Minutes – Executive Policy Committee – January 19, 2022

Item No. 2 Development Agreement Amendment – File DASZ 10/2013 (AG 10/13) (Transcona Ward)

Title: Development Agreement Amendment – File DASZ 10/2013 (AG 10/13)

SCHEDULE 'G'

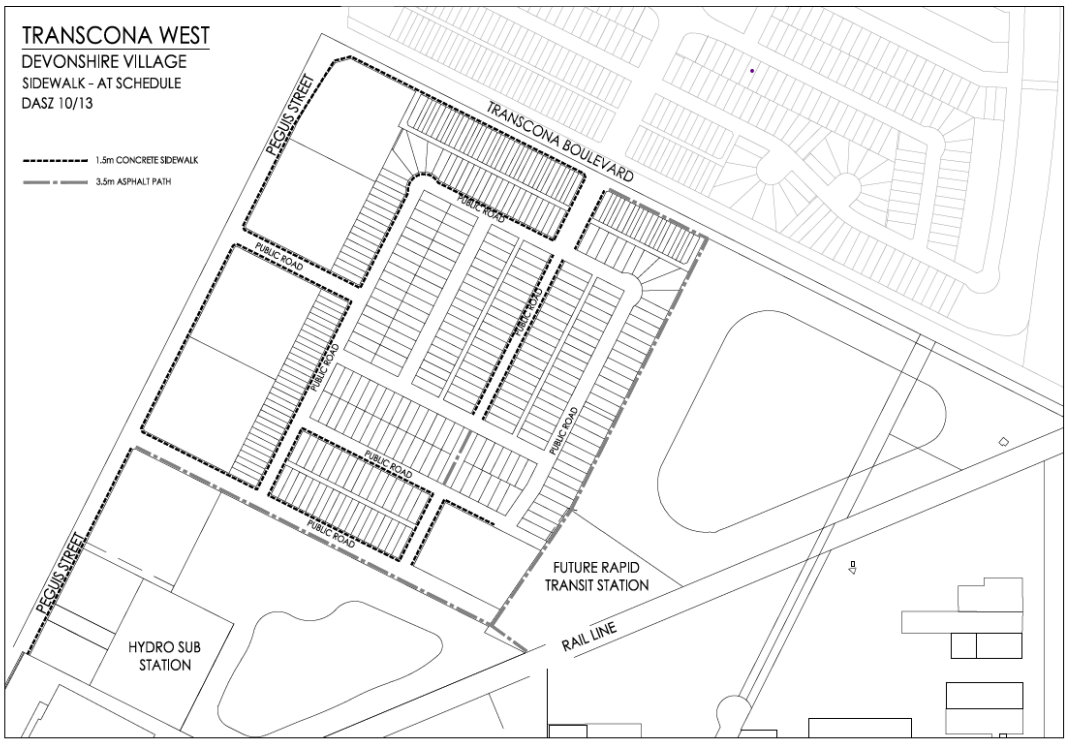
- Amend Schedule "G" to:
  Remove the requirement for a sidewalk connection from Larry Vickar Drive East to the Deep Pond AT pathway (as shown on the attached map).

Comments
The objective of the proposed amendment is to delete the sidewalk connection from Larry Vickar Drive East to the deep pond AT pathway. This connection is redundant as there is east-west connection to the deep pond AT path along Transcona Boulevard to the north and Cal Gardner Drive to the south. This specific agreement provision was added by the City during the public hearing for DASZ 10/13 without opportunity to fully review the feasibility of the requirement in relation to site characteristics. The existing grades in the area do not make it reasonable or possible to construct the public walkway to universal design standards. As such, Genstar is proposing that the sidewalk be removed and replaced with an informal, low maintenance granular pathway. The surrounding public reserve area will be developed with low/no maintenance naturalized plantings and grasses, and landscaping boulders. The intent is to provide an informal and passive connection to the deep pond AT path while using design interventions to discourage unsafe travel.

REVISED SCHEDULE G

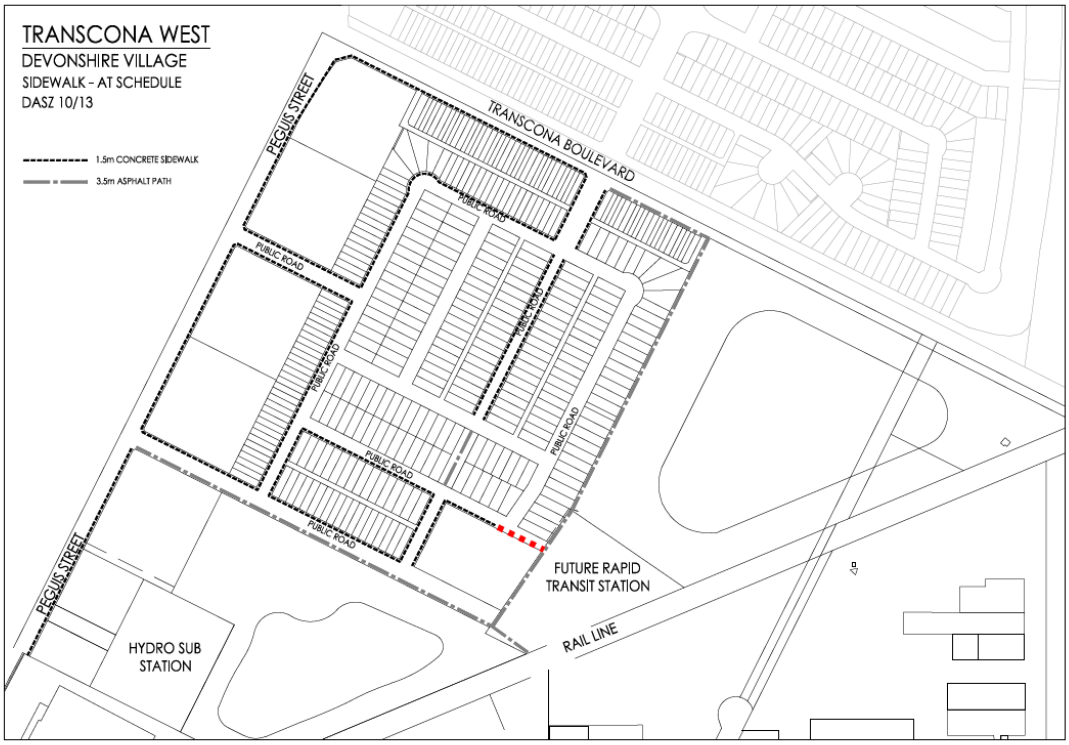
The Public Service has recommended approval of the request, subject to the Developer, at no expense to the City, consolidating the Public Reserve with the adjacent properties (as applicable) and constructing an alternative sidewalk connection at the southeast corner of Larry Vickar Drive East, as noted in Appendix B.

B. Delete Schedule G in its entirety, and replace with “Revised Schedule G” attached to this report as “Appendix B”,

a. The Developer shall, at no expense to the City, supply and install barrier fencing between the existing (west) front and (east) rear pillars, including a 2.4 m (8 foot) wide, double gated access for maintenance; signage at the west and east limits of the public reserve advising of the alternate access path; naturalized plantings for the area enclosed by the fencing; and sod for the area between the boulevard and proposed west fence, within the Public Reserve located between 87 Larry Vickar Drive East and 95 Larry Vickar Drive East, as determined by and to the satisfaction of the Director of Public Works.

b. The Developer shall, at no expense to the City, supply and install one bench within an asphalt bench node and all related works, adjacent to the Public Reserve described in clause a. above, flanking the Deep Pond multi-use pathway, to the satisfaction of the Director of Public Works.
